DESIGN	CP	DART AEROSPACE LTD HAWKESBURY, ONTARIO, CANADA	
DRAWN	RF		
CHECKED	CP	DRAWING NO. D407-667-145	REV. C SHEET 4 OF 4
MFG. APPR.	CP	TITLE	SCALE
APPROVED	CP	CROSSTUBE ASS'Y (407 HIGH FWD)	NTS
DE APPR.	CP	COPYRIGHT © 2002 BY DART AEROSPACE LTD	
DATE	08.11.06	THIS DOCUMENT IS PRIVATE AND CONFIDENTIAL AND IS SUPPLIED ON THE EXPRESS CONDITION THAT IT IS NOT TO BE USED FOR ANY PURPOSES OR COPIED OR COMMUNICATED TO ANY OTHER PERSON WITHOUT WRITTEN PERMISSION FROM DART AEROSPACE LTD.

DRAWING NO. D407-667-145	TITLE CROSSTUBE ASS'Y (407 HIGH FWD)	REV. C	DART AEROSPACE LTD ENGINEERING ORDER		D.E.O. NO. D407-667-145-C-1	SHEET NO. SHEET 1 OF 1	SCALE NTS
DRAWN 9	CHECKED 155	MFG. APPR. 155	APPROVED 155		DE APPR. 155		
DATE 11.07.15	DATE 11.07.22	DATE 11.07.22	DATE 11/07/22		DATE 11.07.21

DRAWING NO. D407-667-145	TITLE CROSSTUBE ASS'Y (407 HIGH FWD)	REV. C	DART AEROSPACE LTD ENGINEERING ORDER		D.E.O. NO. D407-667-145-C-2	SHEET NO. SHEET 1 OF 1	SCALE NTS
DRAWN AJS	CHECKED A	MFG. APPR. E	APPROVED AP	DE APPR. H	DATE 12.08.02	DATE 12.08.02	DATE 12.08.02

C TURNING DETAIL

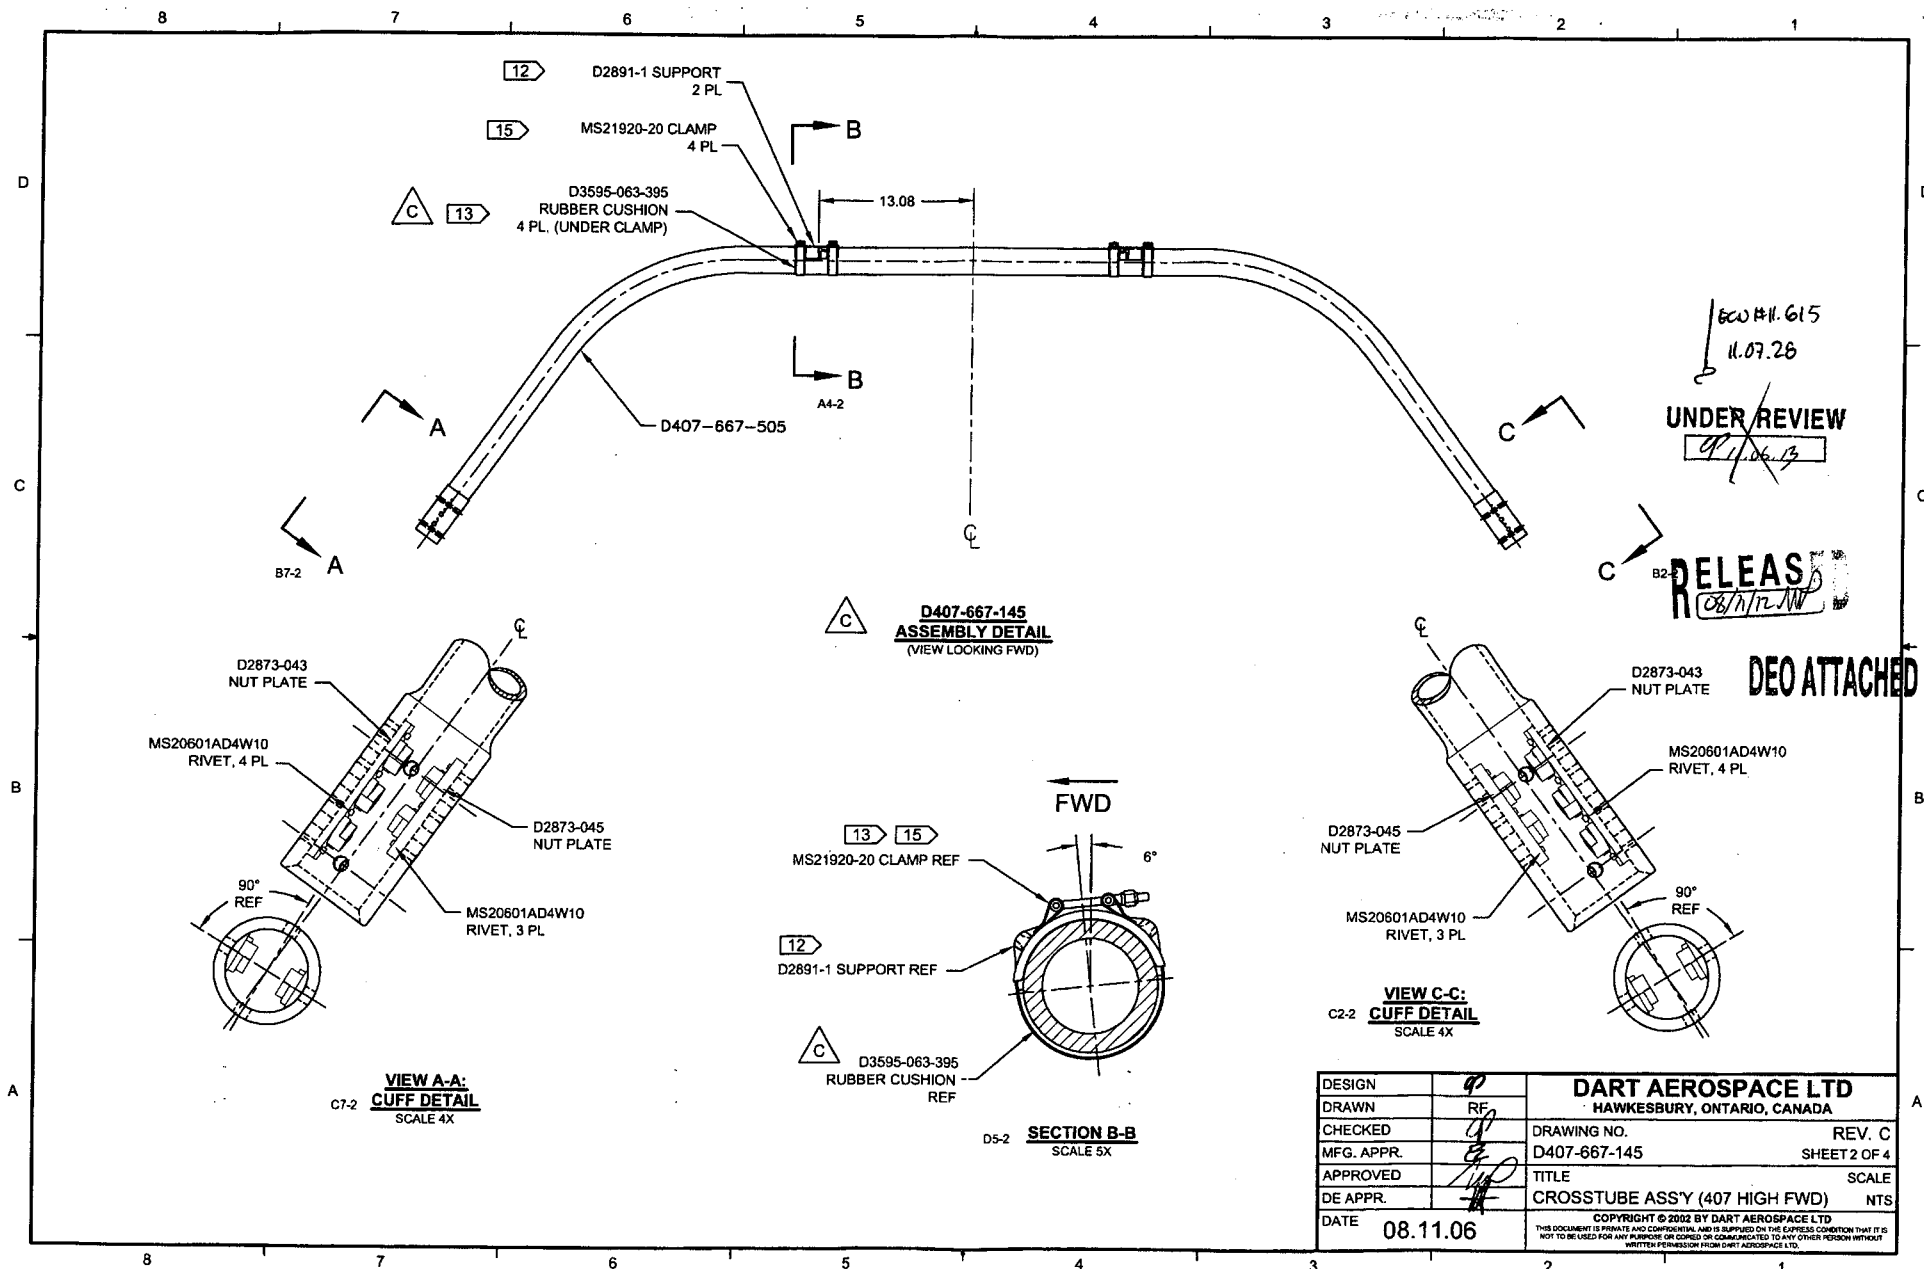
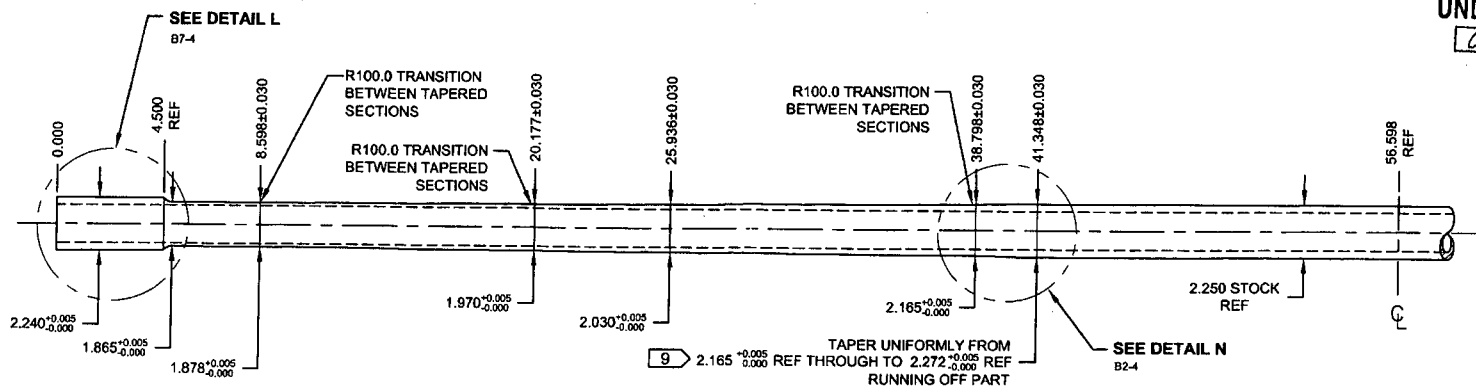
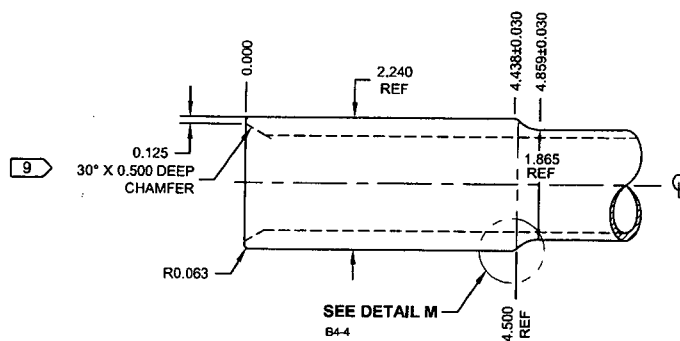
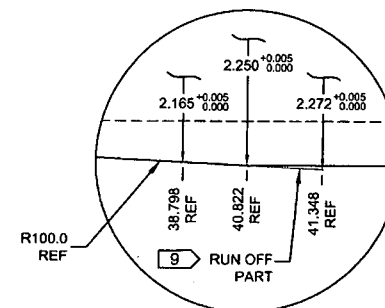
C	REVISE GENERAL NOTES/PART LIST (ZN D7-1); REORGANIZED VIEWS AND REFORMATTED DRAWING TO CURRENT STANDARDS. D3595-063-395 WAS D2856-400-694 (ZN D6-2 & A5-2); REMOVED REF. 7 ADD TOLERANCES (ZN C6-3, C4-3, D2-3); RELOCATED FLAG #6 (ZN A8-3) PER NCR 210; MOVED TURNING DETAIL & UPDATED TOLERANCE TO SHEET 4.	RF	08.11.06
B	ADD HOLES AND NUT PLATES FOR COMPATABILITY WITH BHT/AA SKUDTUBES	PH	05.07.26
A	NEW ISSUE	CP	02.05.08
REV.	DESCRIPTION	BY	DATE
DESIGN	RF	DART AEROSPACE LTD HAWKESBURY, ONTARIO, CANADA	
DRAWN	RF	DRAWING NO.	REV. C
CHECKED	RF	D407-667-145	SHEET 1 OF 4
MFG. APPR.	RF	TITLE	SCALE
APPROVED	RF	CROSSTUBE ASS'Y (407 HIGH FWD)	NTS
DE APPR.	RF	COPYRIGHT © 2002 BY DART AEROSPACE LTD THIS DOCUMENT IS PRIVATE AND CONFIDENTIAL AND IS SUPPLIED ON THE EXPRESS CONDITION THAT IT IS NOT TO BE USED FOR ANY PURPOSE OR COPIED OR COMMUNICATED TO ANY OTHER PERSON WITHOUT WRITTEN PERMISSION FROM DART AEROSPACE LTD.

DETAIL P
BONDING STRAP INSTALLATION 2 PL

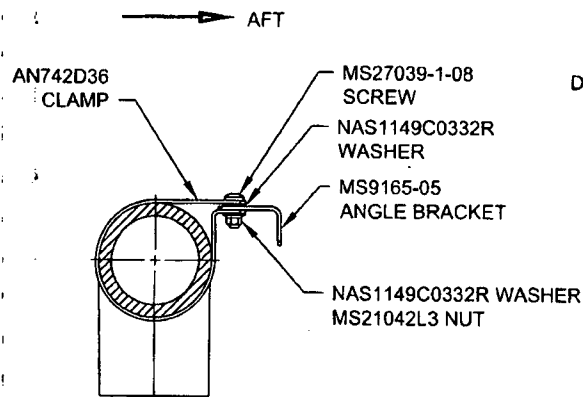
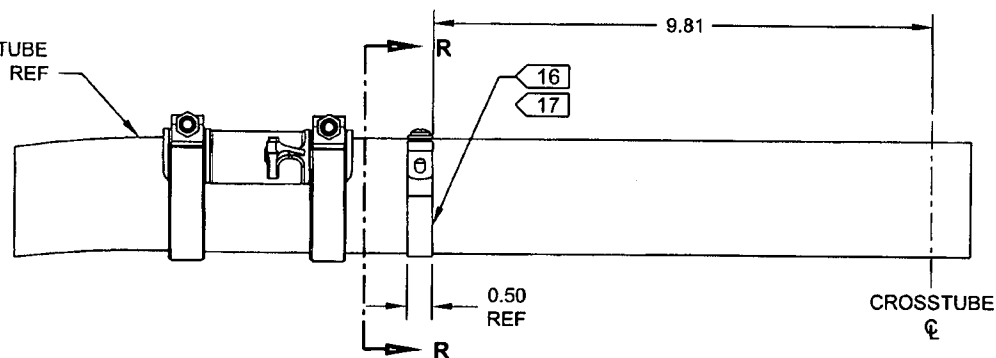
ADD ELECTRICAL GROUNDING STRAP

ITEM	QTY -145	PART NUMBER	DESCRIPTION
1	X	D407-667-145	CROSSTUBE ASSEMBLY (407 HIGH FWD)
10	2	AN742D36	CLAMP
11	2	MS9165-05	ANGLE BRACKET
12	2	MS21042L3	NUT (OR MS21042-3)
13	2	MS27039-1-08	SCREW
14	4	NAS1149C0332R	WASHER (OR AN960C10L)

- 16) MASK AREA UNDER CLAMP PRIOR TO PAINTING
- 17) SEAL EDGES WHERE AN742D36 CLAMP MEETS WITH THE CROSSTUBE USING SIKAFLEX-241/-291 OR MIL-S-8802 CLASS B2 OR PROSEAL 890 SEALANT
- 18) PERFORM RESISTANCE CHECK TO ENSURE MAX RESISTANCE IS 10 MILLIOHMS
